STAFF RECOMMENDATION

911 Lawrence Avenue

December 16, 2020

Application: New Construction—Addition

Figure 1: 911 Lawrence Avenue.

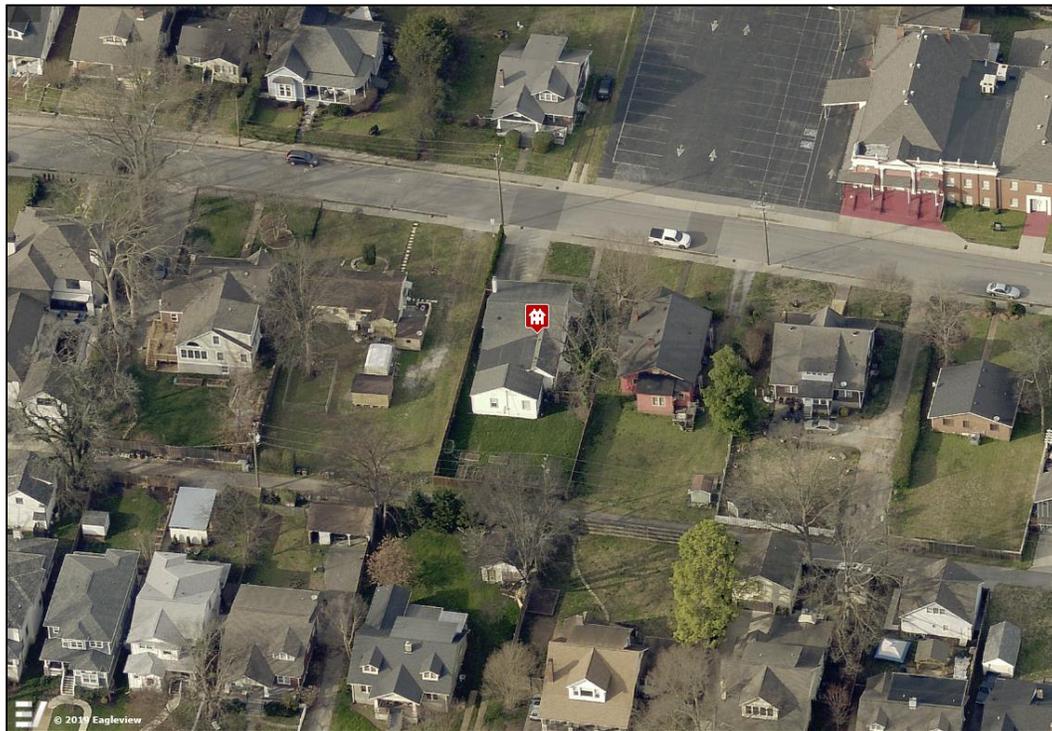
Background: The house at 911 Lawrence Avenue is a one-story bungalow with Craftsman and Tudor Revival details. The house has a side-gabled roof with a partial-width recessed front porch. The house has been enlarged with a rear addition, but the original appearance of the house from the front is intact.

The house, which was constructed circa 1920, contributes to the historic character of the neighborhood due to its age and architectural character.

Figure 2: Right side, viewed from rear.

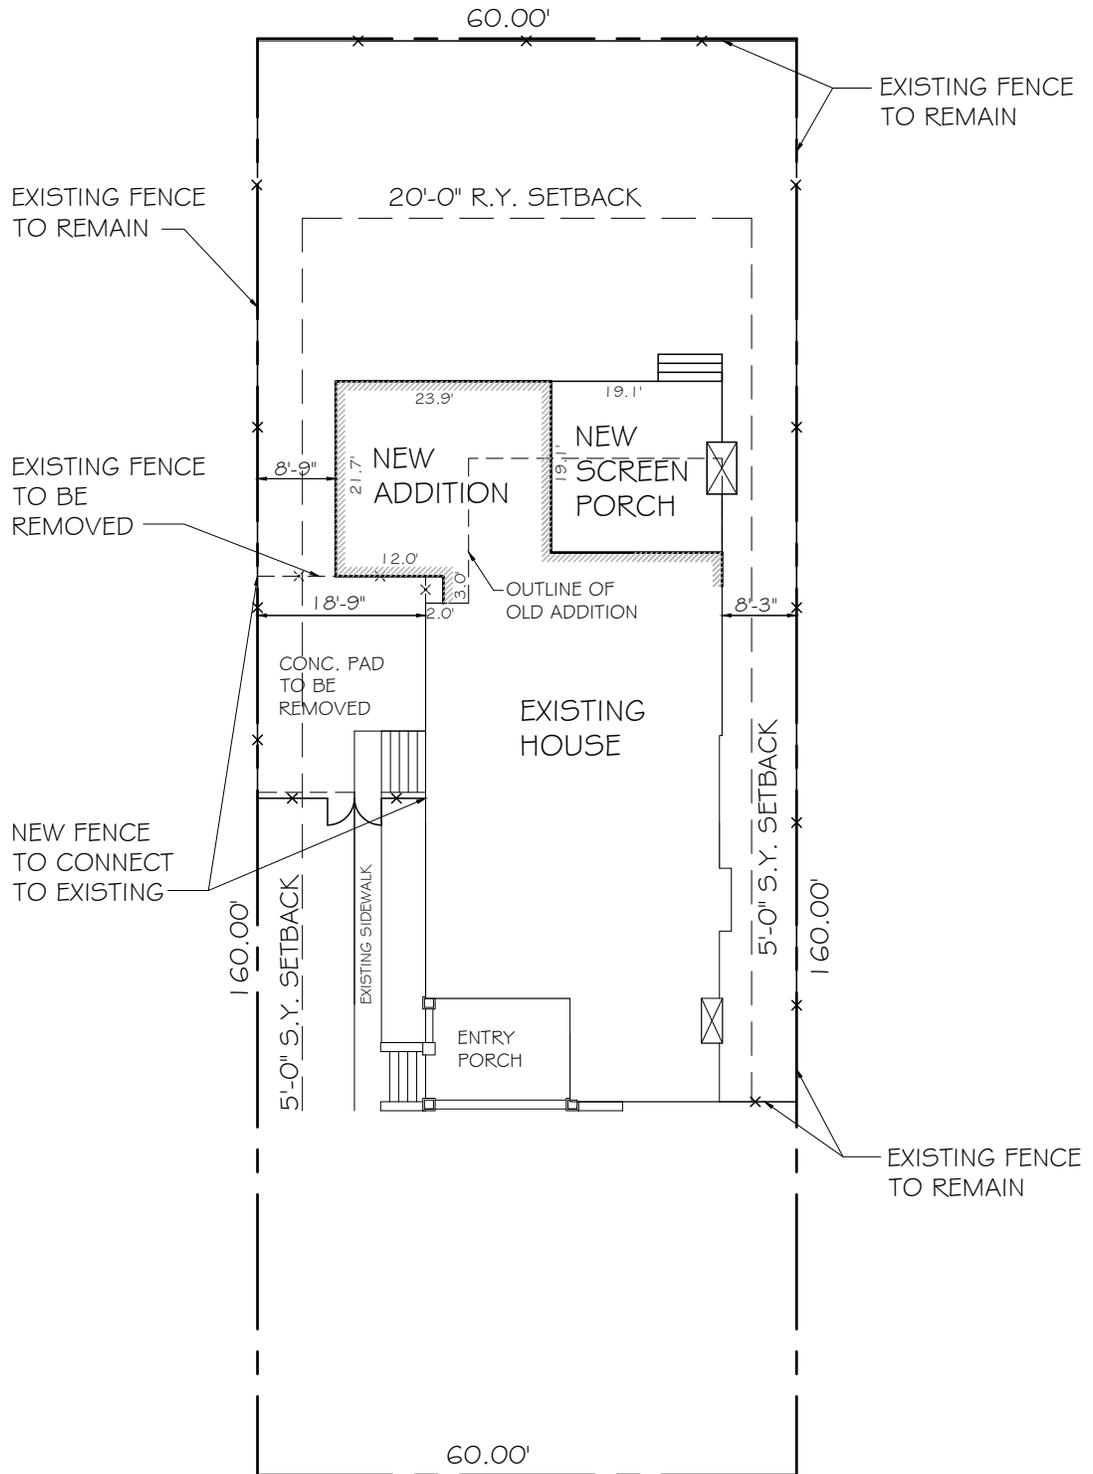
Location & Removability: The addition will attach to the historic house at the rear, stepping in two feet (2') from the left side wall and flush with the original side wall on the right side. Typically, additions are required to step in at least one foot (1') on both sides to preserve the building's historic form, but Staff finds that an inset on the right side is not necessary because the previous addition was not stepped in.

After stepping in for a span of three feet (3'), the addition will step out to the left, going ten feet (10') wider than the historic house. Additions should generally be behind an historic house, although the Commission has approved wider additions to houses that are atypically narrow, are shifted to one side of a lot, or are on an atypically wide lot. Staff finds the wider addition to be appropriate here because the lot is sixty feet (60') wide and the house is shifted to the right side of the lot.

Staff finds that the location and attachment of the addition, stepping in from the left side and flush with the right-side wall to meet Sections IV.A, E and IV.F of the design guidelines for additions.

PROPOSED SITE PLAN

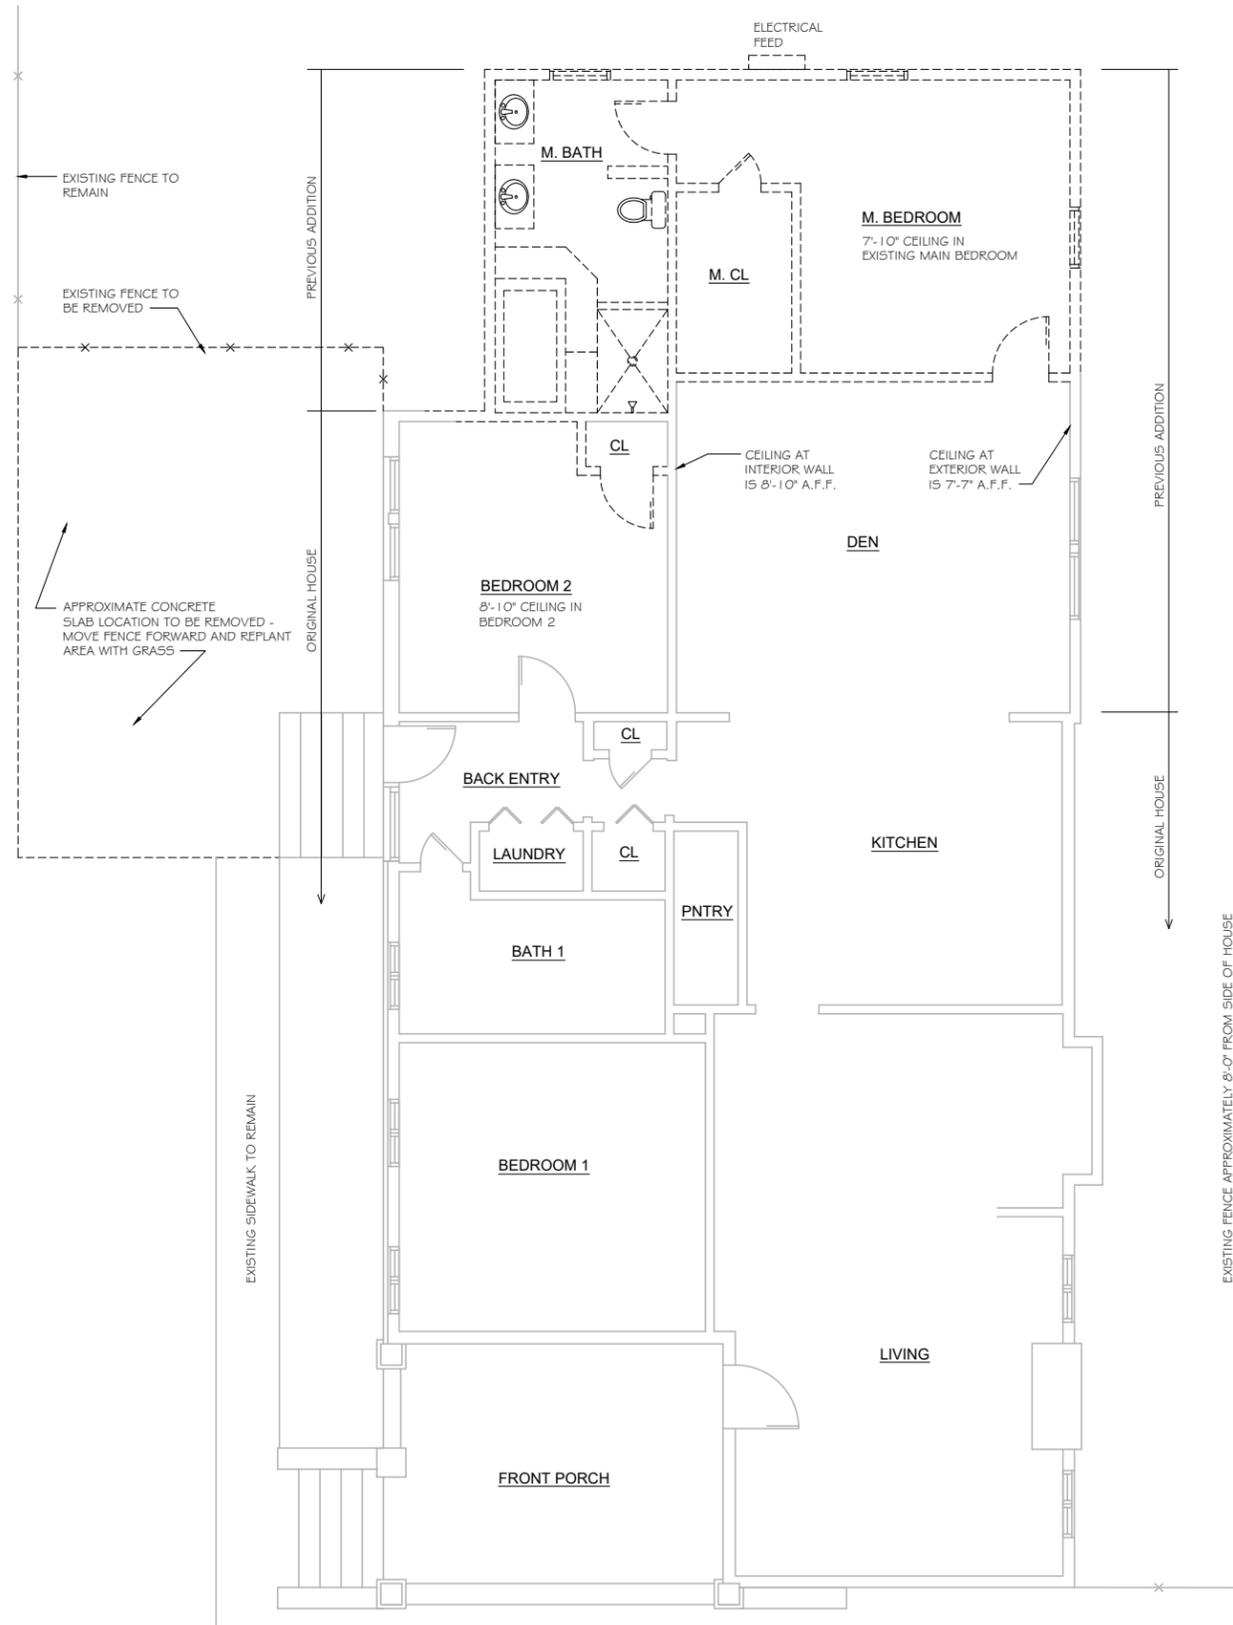
Setback & Rhythm of Spacing: With the addition extending ten feet (10') to the left, the space between 911 Lawrence Avenue and 909 Lawrence to the left will be affected. Staff finds that the resulting spacing will still be appropriate because the house at 911 Lawrence Avenue is shifted to the right side of the lot, and because the additional width is behind the massing of the historic house.

The right side of the addition will match the existing setback, with a chimney extending eighteen inches (18') to the right. The existing right-side setback is eight feet (8'), therefore the chimney does not encroach into the standard five foot (5') setback buffer.

Staff finds the project meets section III.C for setback and rhythm of spacing for additions.

NEW CONSTRUCTION FLOOR PLANS

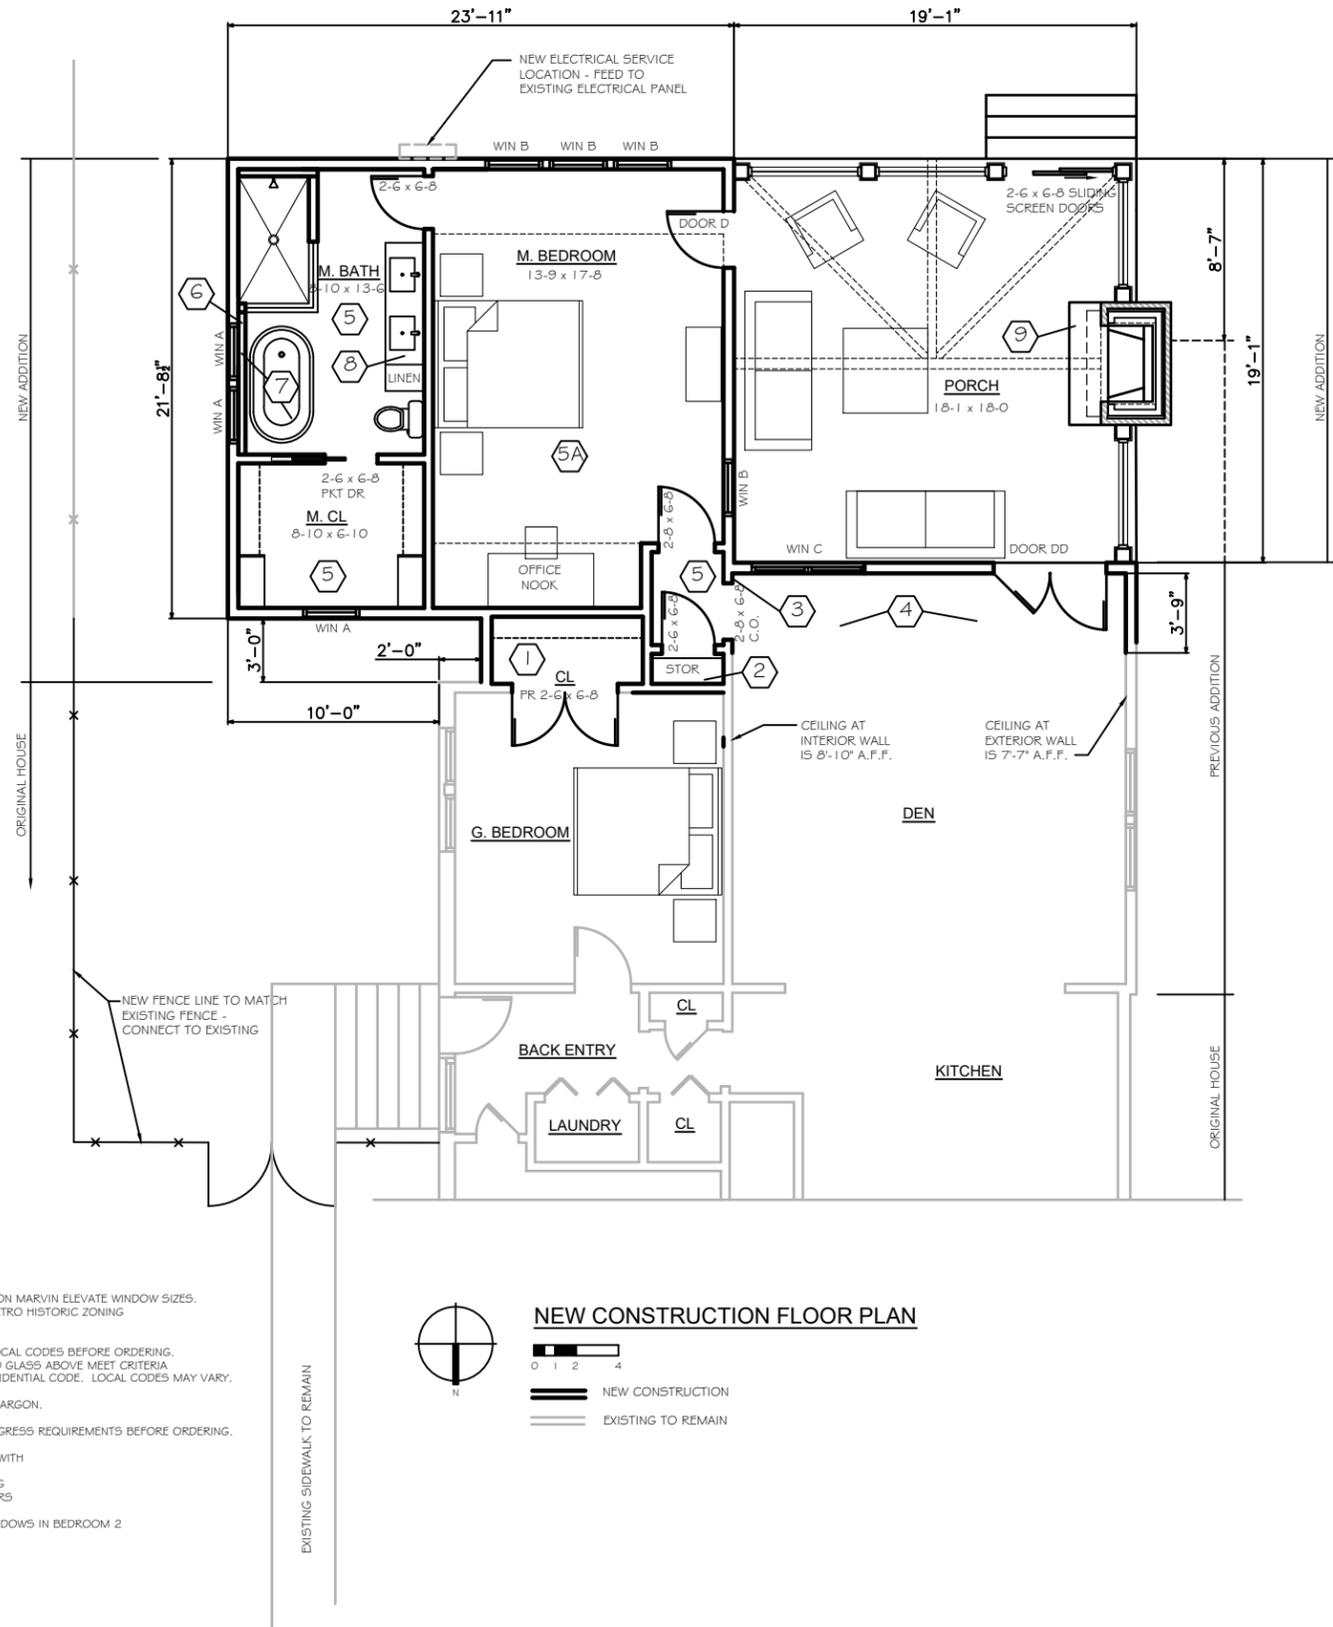
The addition extends ten feet (10') wider than the historic house to the left side, which is only one third (1/3) of the width of the thirty-foot (30') wide house. The Commission has allowed wider additions to be as much as one half (1/2) the width of an historic house. The addition will extend twenty-three feet (23') to the rear, increasing the depth of the house by less than one half of its current depth of fifty-two feet (52').

Staff finds that the height and scale of the addition is compatible with the historic house, and it will meet sections IV.B, and IV.G of the design guidelines.
